LTR-NRC-12-47

Subject: Response to the NRC's Request for Supplemental Information on WCAP-17483-P, "Westinghouse Methodology for Spent Fuel Pool and New Fuel Rack Criticality Safety Analysis" (Proprietary/Non-Proprietary)

**Response to NRC Request for Supplemental Information on
WCAP-17483-NP, "Westinghouse Methodology for Spent Fuel Pool and New Fuel Rack Criticality
Safety Analysis" (Non-Proprietary)**

Figure 4-1 ENDF-VI pointwise total cross section data for Gd-155(green), Gd-157 (light green), B-10 (red), Er-166 (purple) and Er-167 (blue)

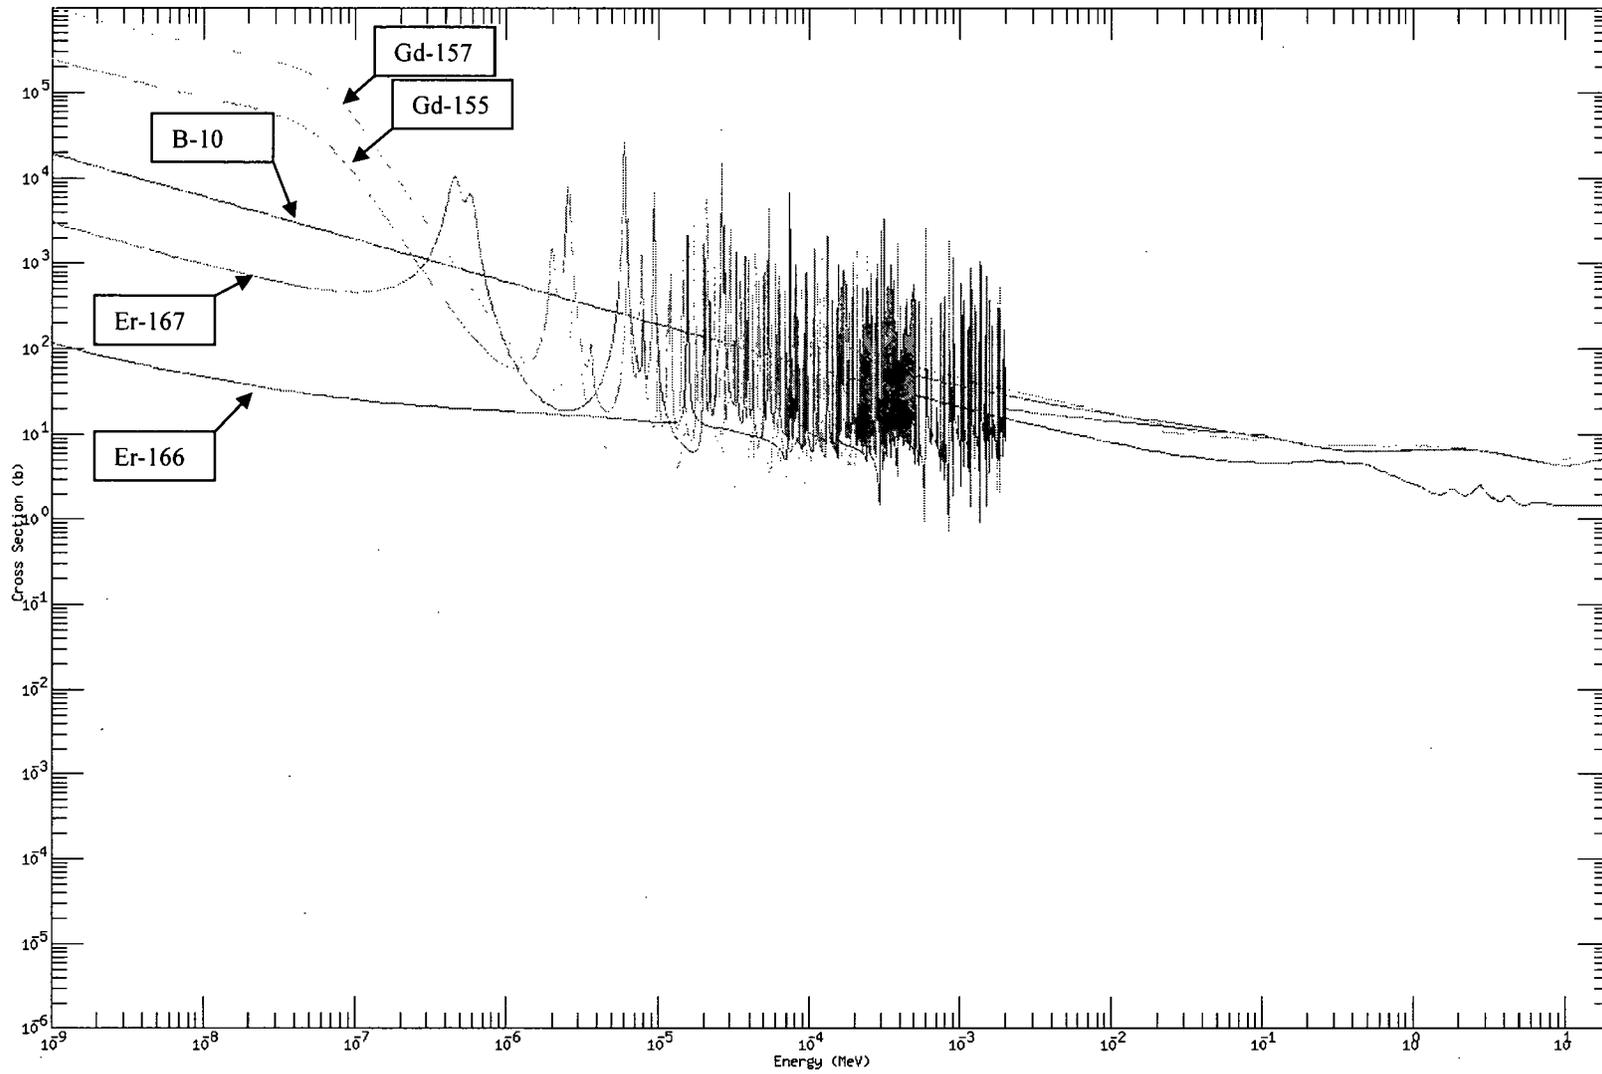
RSI Question 4. The information provided in NUREG/CR-6760, "Study of the Effect of Integral Burnable Absorbers for PWR Burnup Credit," is insufficient in of itself to draw the conclusion that it is always conservative to not model Erbium and Gadolinium as integral poisons. Additionally, besides IFBA, Erbium, and Gadolinium, NUREG/CR-6760 does not consider other potential integral neutron absorbers. Provide the analysis that demonstrates that not modeling Erbium and Gadolinium as integral poisons is always conservative, within the scope of the methodology. The NRC staff expects neutron absorbers not explicitly demonstrated within TR to be outside the scope of methodology.

Response: NUREG-6760 reviews the use of Integral Burnable Absorbers (IBAs) for their impact on reactivity and concludes:

"The analyses described in this report conclusively demonstrate that, with the exception of the Westinghouse IFBA rods, the neutron multiplication factor for an assembly without IBAs is always greater (throughout burnup) than the neutron multiplication factor for an assembly with IBAs, including $\text{UO}_2\text{-Gd}_2\text{O}_3$, $\text{UO}_2\text{-Er}_2\text{O}_3$, and $\text{Al}_2\text{O}_3\text{-B}_4\text{C}$ rods. Therefore, for those IBAs other than IFBAs, burnup credit criticality safety analyses may simply and conservatively neglect the presence of the IBAs by assuming nonpoisoned equivalent enrichment fuel. Considering the variations in IBA assembly designs, neglecting the presence of the IBAs is an important simplifying assumption that does not add significant unnecessary conservatism."

The analyses performed in developing the NUREG-6760 conclusion involved both calculations of an infinite array of assemblies (without fixed poison panels) and cask criticality calculations which included fixed poison panels between assemblies. The IBAs included in the study which relate to this question are $\text{UO}_2\text{-Gd}_2\text{O}_3$ (gadolinia) and $\text{UO}_2\text{-Er}_2\text{O}_3$ (erbia). There were two fuel assembly types used in the gadolinia pin studies, a Siemens 17x17 fuel lattice similar to the Westinghouse 17x17 Standard design, and a CE 16x16 fuel lattice. The erbia pin studies were performed with a CE 14x14 fuel lattice.

The gadolinia study was performed using a 2 dimensional transport code, HELIOS, and included calculations in which both the number and weight percent (wt%) of the gadolinia were varied. A parametric study of the impact of ^{235}U enrichment was also performed. The results of these studies showed that for the two fuel designs, ignoring the presence of gadolinia in depletion was always conservative at all enrichments and with and without fixed poison panels considered.
